Well Name: TRIPLE S 33 FED	Well Location: T23S / R31E / SEC 33 / SWNE / 32.262715 / -103.7816363	County or Parish/State: EDDY / NM
Well Number: 1	Type of Well: OTHER	Allottee or Tribe Name:
Lease Number: NMNM45236	Unit or CA Name:	Unit or CA Number:
US Well Number: 3001525769	Operator: OXY USA INCORPORATED

Type of Action: Plug and Abandonment

NOI TO PERMANENTLY ABANDON THIS WELL VIA CEMENT PLUGGING.

**Permanent Abandonment of Federal Wells
Conditions of Approval**

CURRENT WELLBORE

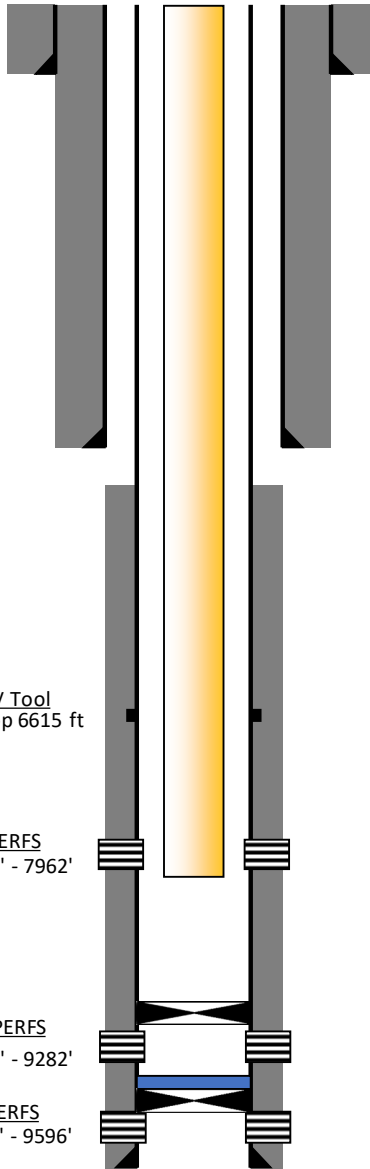
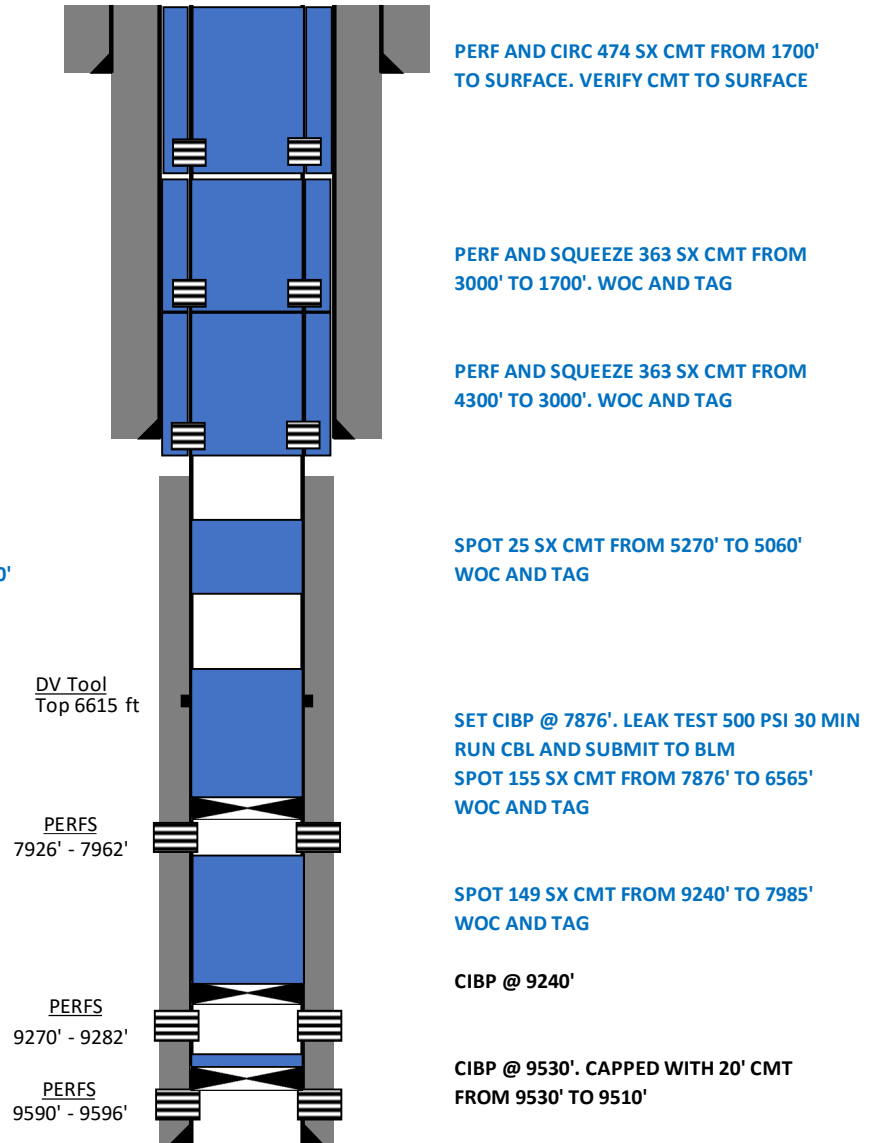
LESSER PRAIRIE CHICKEN AREA. PLEASE REVIEW REQUIREMENTS AND RESTRICTIONS IN COA R111Q POTASH AREA. SALT COVERAGE PROPOSAL OK. PLEASE REVIEW REQUIREMENTS IN COA

INTERNAL SALT:
TOS - 793'
BOS - 3982'
COVERAGE DEPTHS OK
